FIRE SAFETY INSPECTION REPORT

DENITEX LIMITED

ACCORD ID: 12477

Date: March 22, 2016

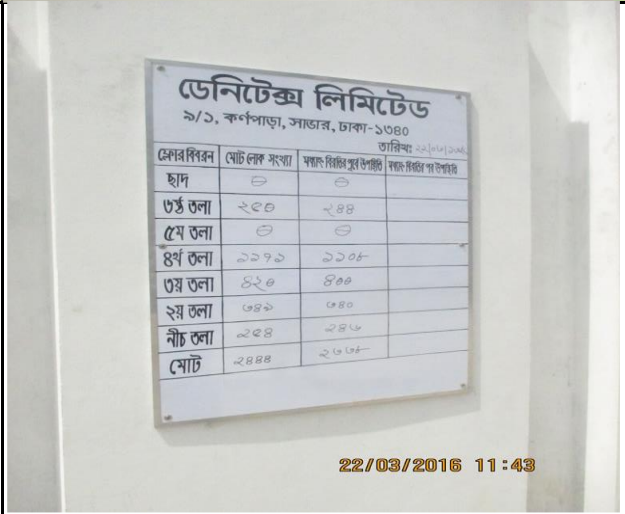
Sl No.	Category	Findings	Required Action	Remediation Time Frame	Pictorial Evidence
4	Fire Rated Construction	Rooms used for storage of combustible materials are not separated from the surrounding occupancy/areas.	Rooms used for storage of combustible materials shall be separated from the surrounding occupancy with a minimum 1 hour construction.	Within 3 months

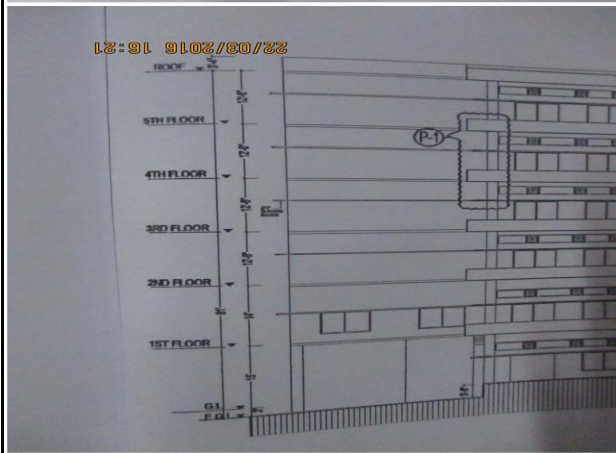
Sl No.	Category	Findings	Required Action	Remediation Time Frame	Pictorial Evidence
11	Egress Lighting	Exit sign not provided on many exits.	Lighted exit signs shall be placed at entrance to an exit. Additional exit signs shall be placed throughout the facility anywhere the continuation of the egress is not obvious. Lighted exit signs shall be provided with either battery backup or uninterruptable power supply systems and shall be continuously illuminated. And Illuminated directional signs shall be provided where there is a change in the direction for the path of travel and the direction to an exit is not obvious.	Immediately
